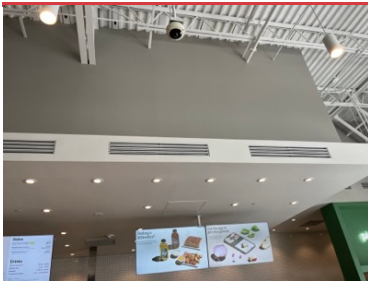
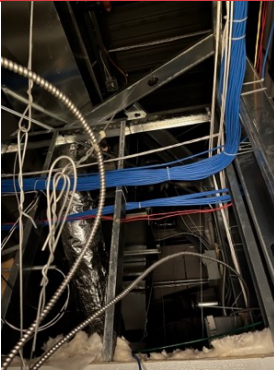
DINING AREA DIFFUSER DAMPERS NOT ACCESSIBLE

RESTROOM EXHAUST DAMPERS NOT PRESENT

UNITS NOT ACCESSIBLE DUE TO HEIGHT AND SPACE RESTRAINTS

AC 2 & 3 LOW FLOW. FANS IN HIGH SPEED.

NTAB discussed with Trane tech and MC regarding AC 2 and 3 being low on flow. NTAB was informed that the only speed control is via the thermostats, in which both units are currently in high speed. Store was comfortable in current conditions, but it is still suggested to increase fan speeds if at all possible on these units.

Unit totals were balanced.

Fan total balanced.
